Development Permit Panel Electronic Meeting

1. **DEVELOPMENT PERMIT 21-940028**
(REDMS No. 7236092)

APPLICANT: The Panatch Group

PROPERTY LOCATION: 10140, 10160, 10180 No.1 Road and 4051 Cavendish Drive

AIR CRAFT CABLE MOUNTING BRACKET DETAIL

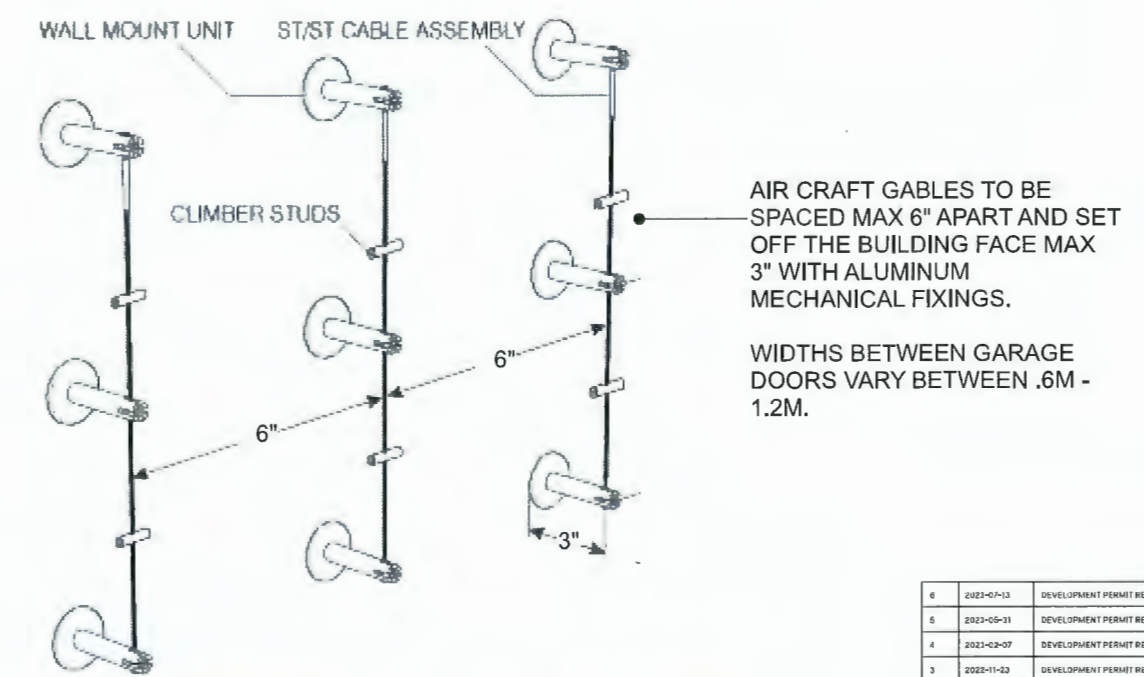
- concerned about the long-term maintenance and survivability of small pockets of planting between garage doors;

The low-level areas of planting between the garage doors and entry doors will be planted with vines and encouraged to grow up a trellis armature of wall mounted aircraft cable. To provide water to these areas a portion of the roof run off will be directed into these areas with a splashpad.
